STAFF REPORT

TO: City Council
FROM: Emily Becker, Planning Director
ITEM: Wildflower at Lake Elmo 3rd Addition Final Plat and Final PUD Plans
REVIEWED BY: Jack Griffin, City Engineer

WILDFLOWER AT LAKE ELMO 3RD ADDITION

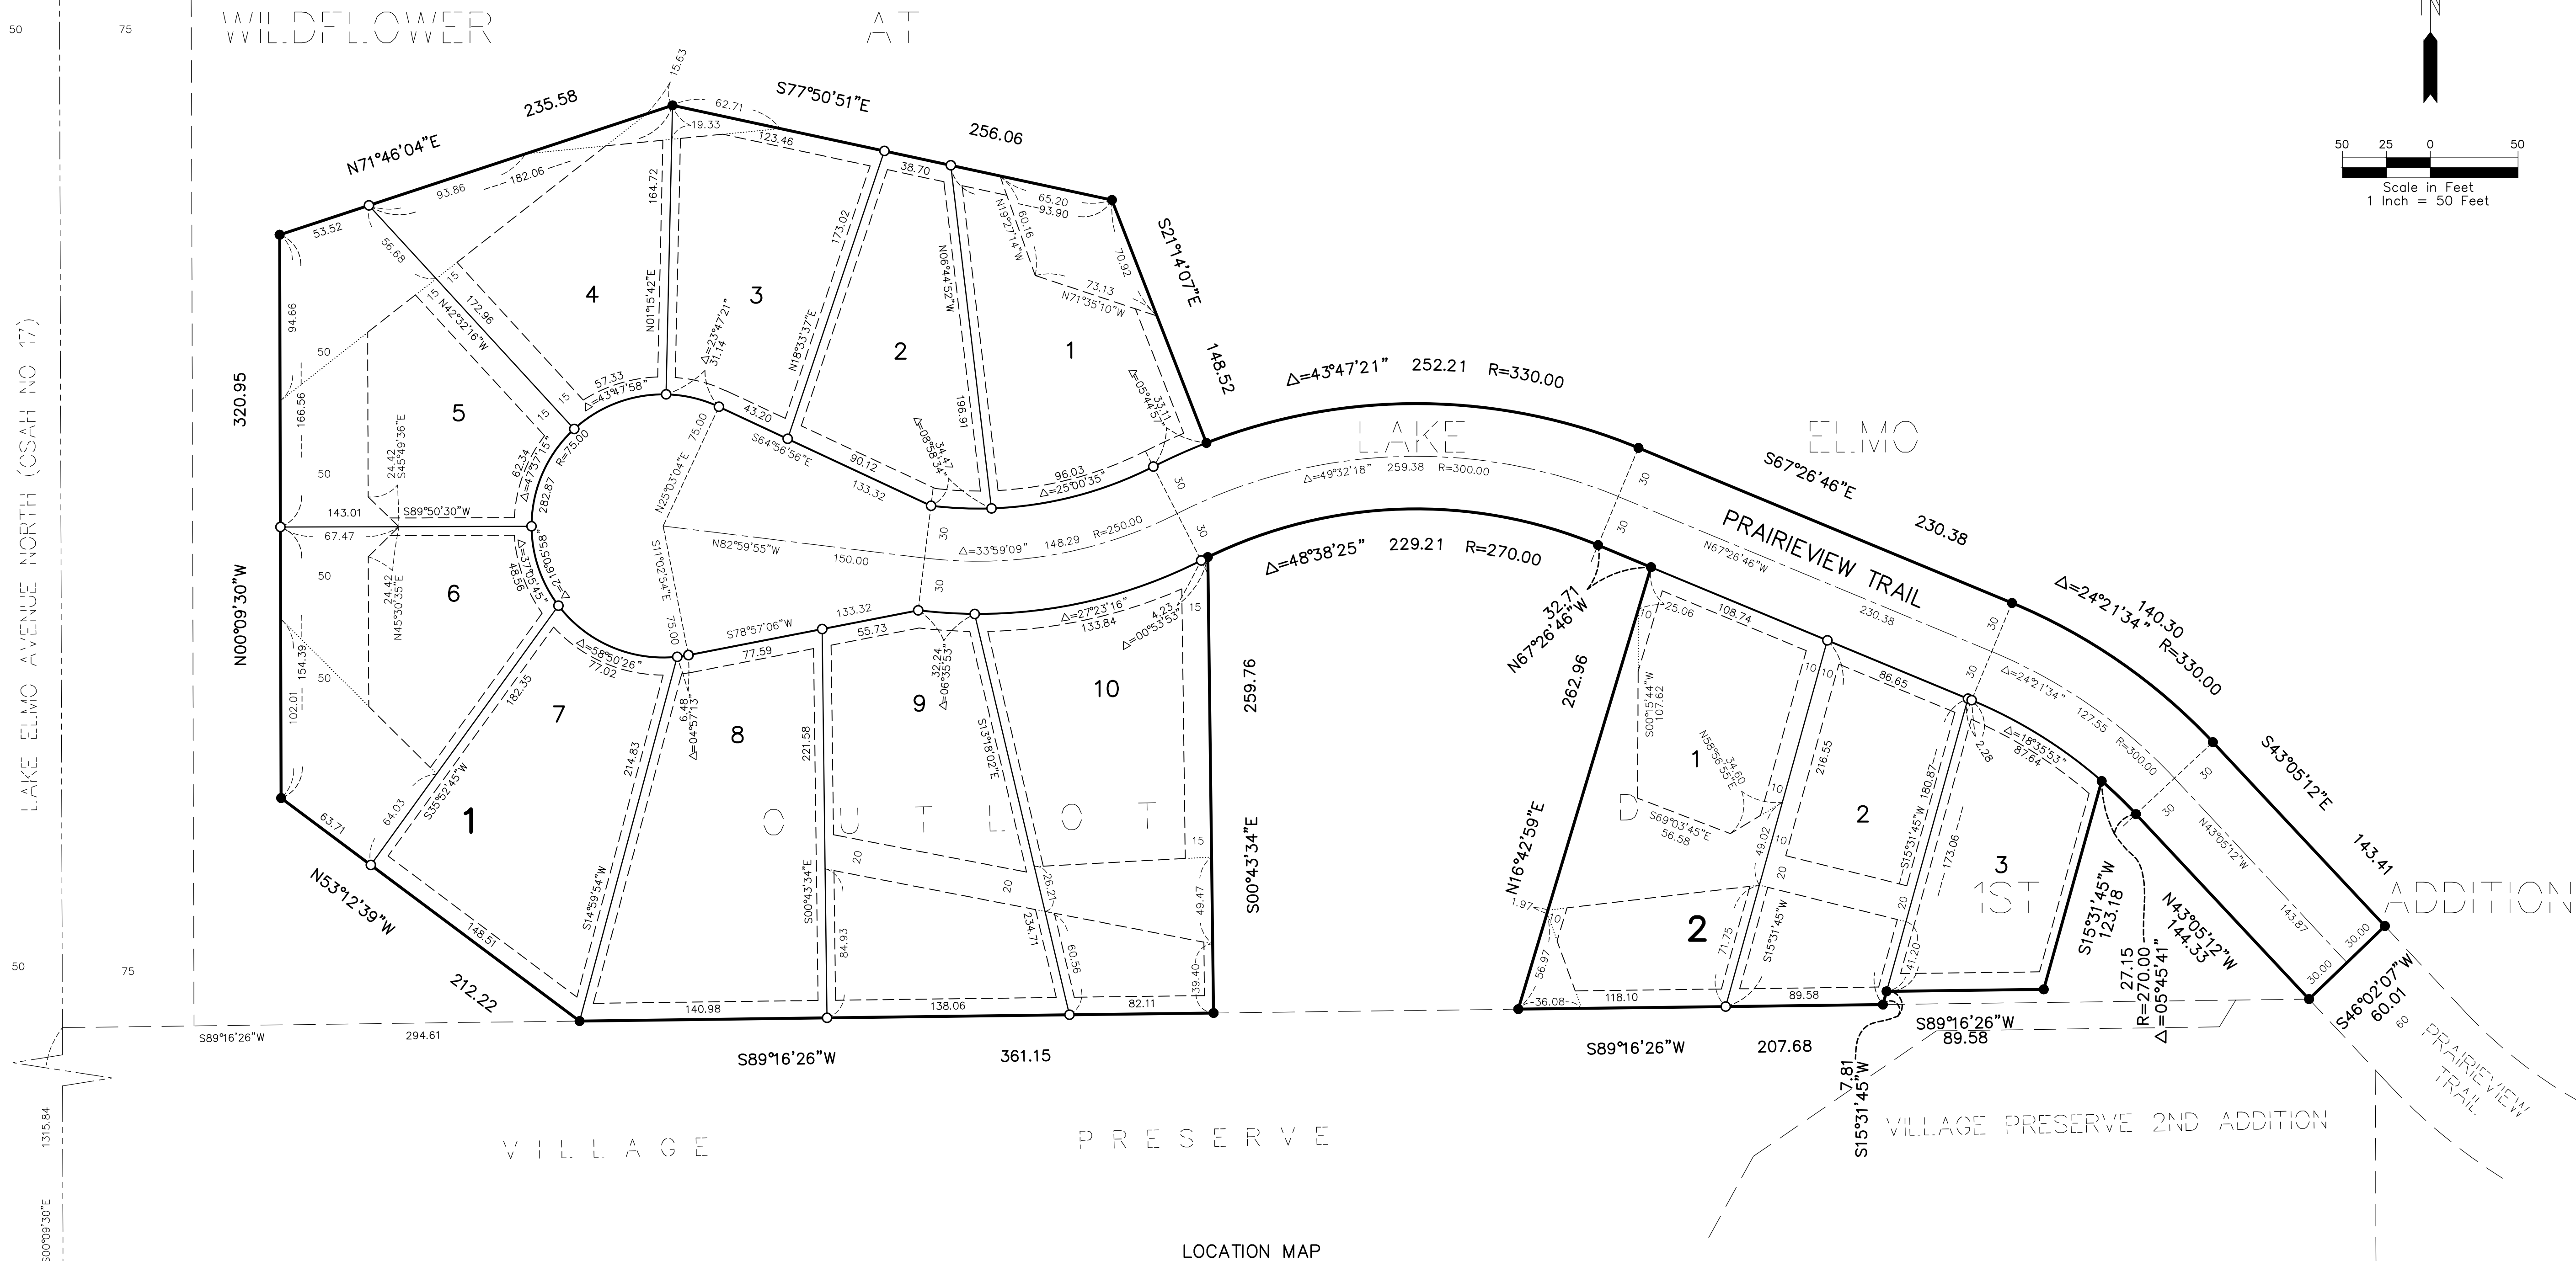
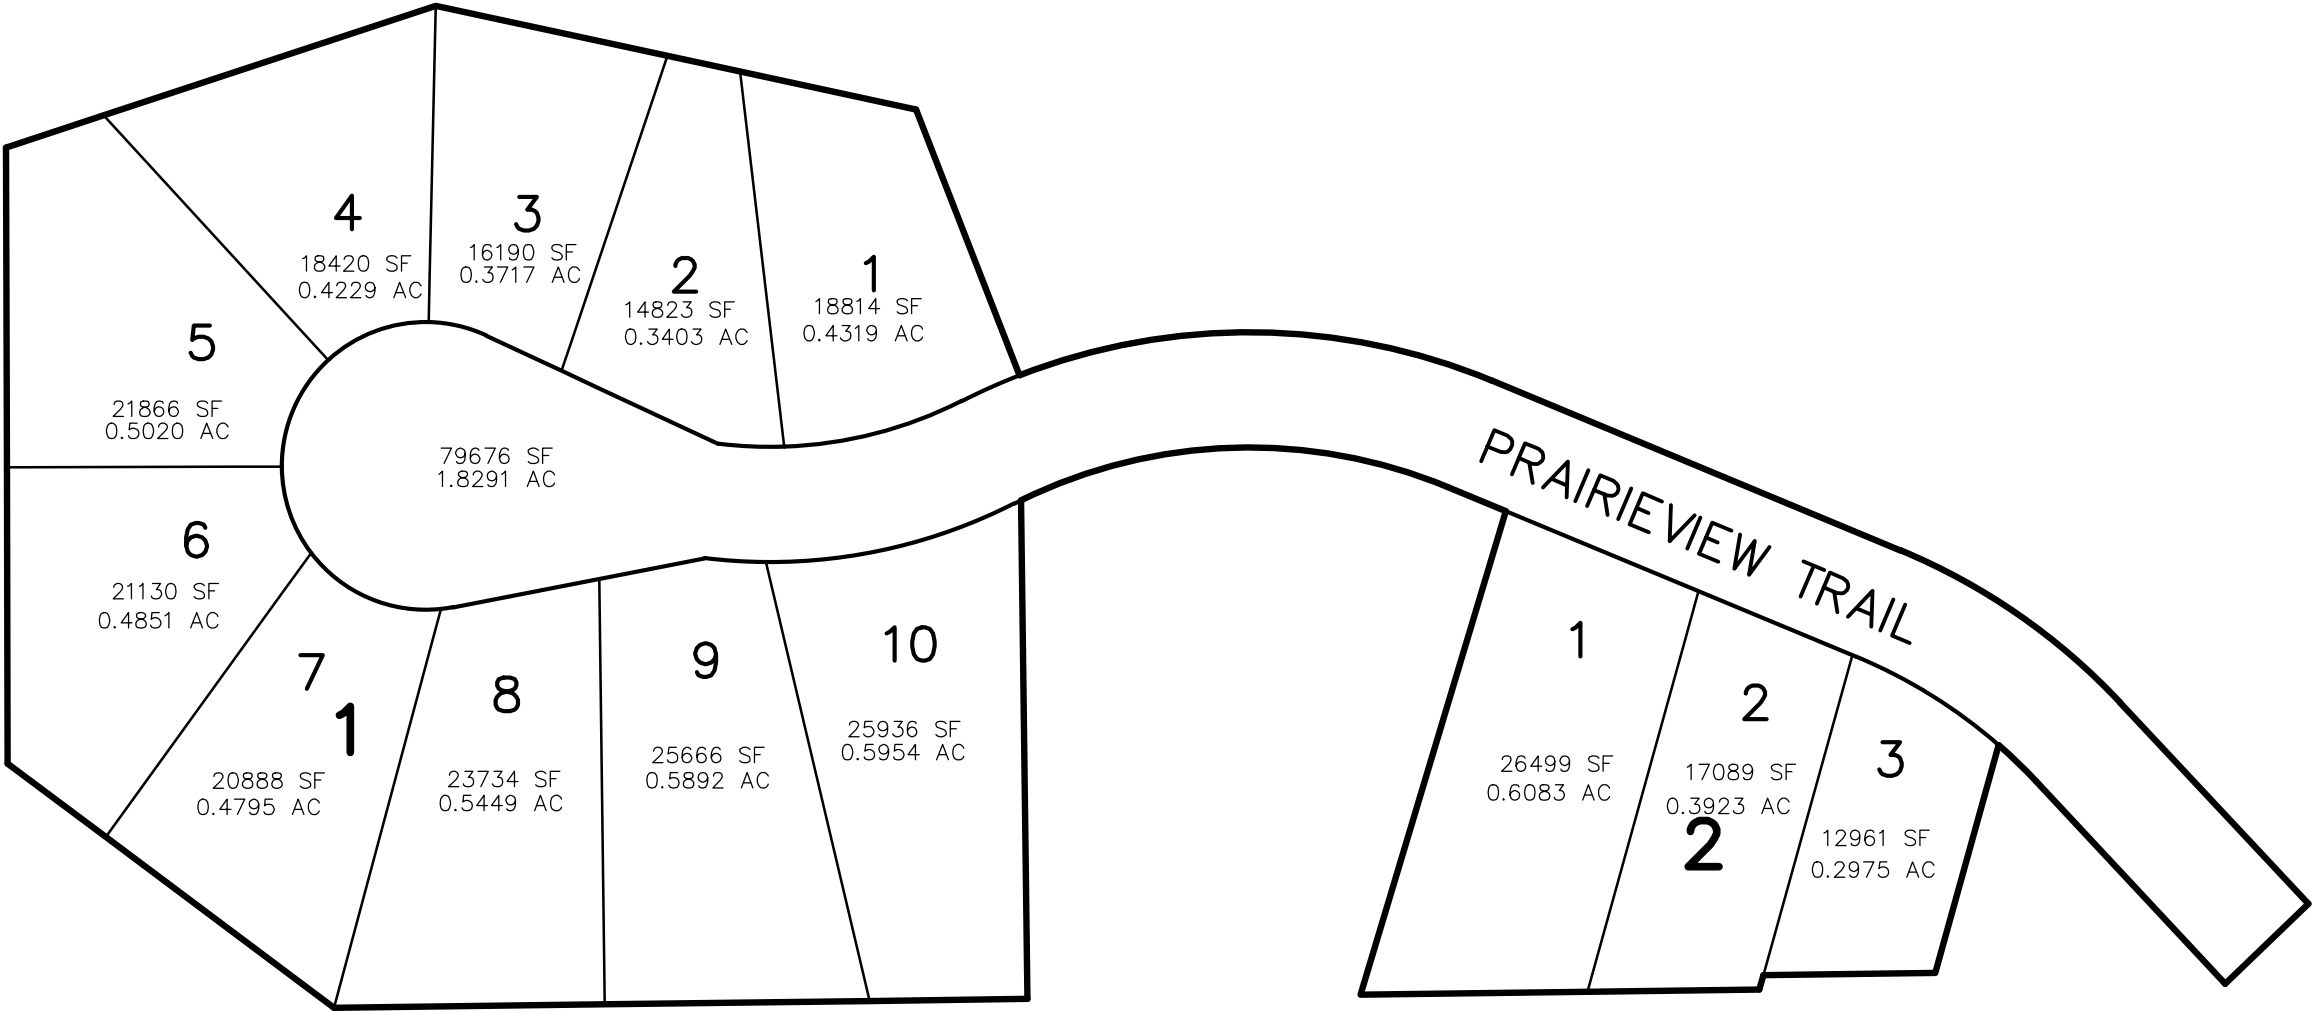
- The Final Plat shall not be recorded until final construction plan approval is granted.
- All easements as requested by the City Engineer and Public Works department shall be documented on the Final Plat prior to the release of the Final Plat for recording.

LANDSCAPE PLAN

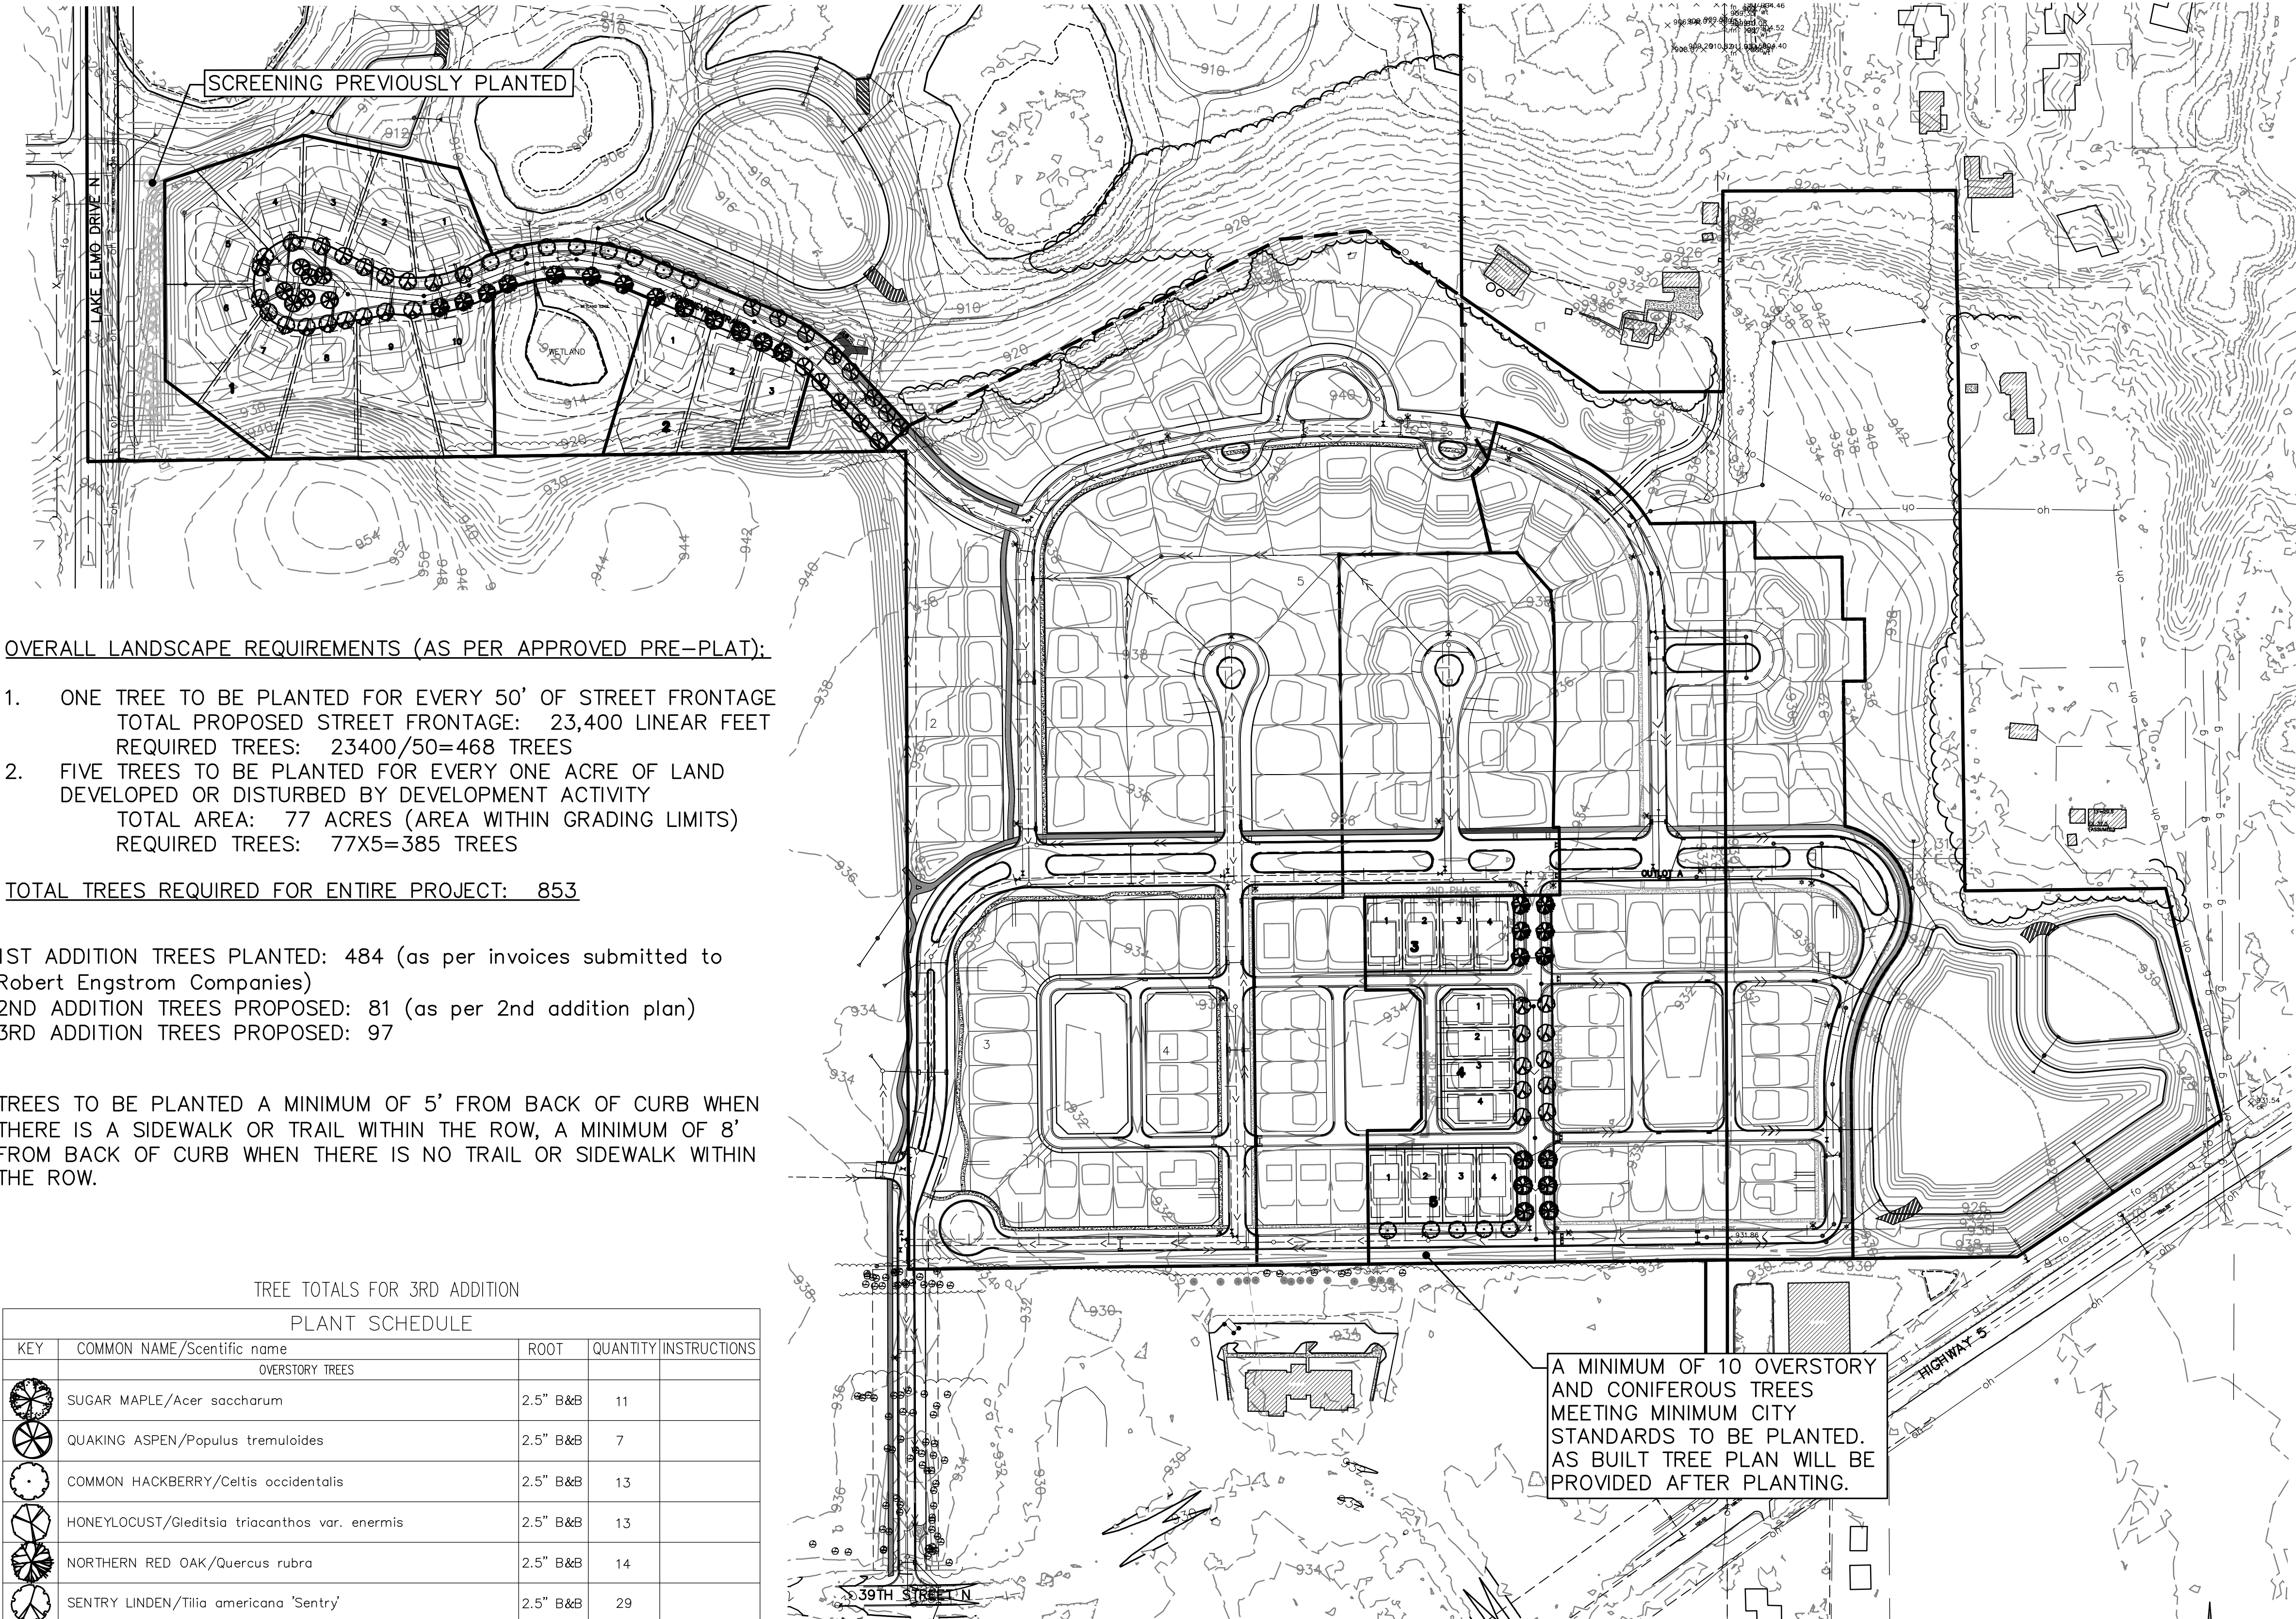
Landscape Plan. A revised landscape plan has been submitted for review, but has not been approved. Approval of the landscape plan should be a condition prior to releasing the plat for recording.

- 6) The landscape plan shall be reviewed and approved by the City prior to releasing the final plat for recording.
- 7) Street signs and no parking signs shall be installed on City Streets within the development prior to any building permits being issued.
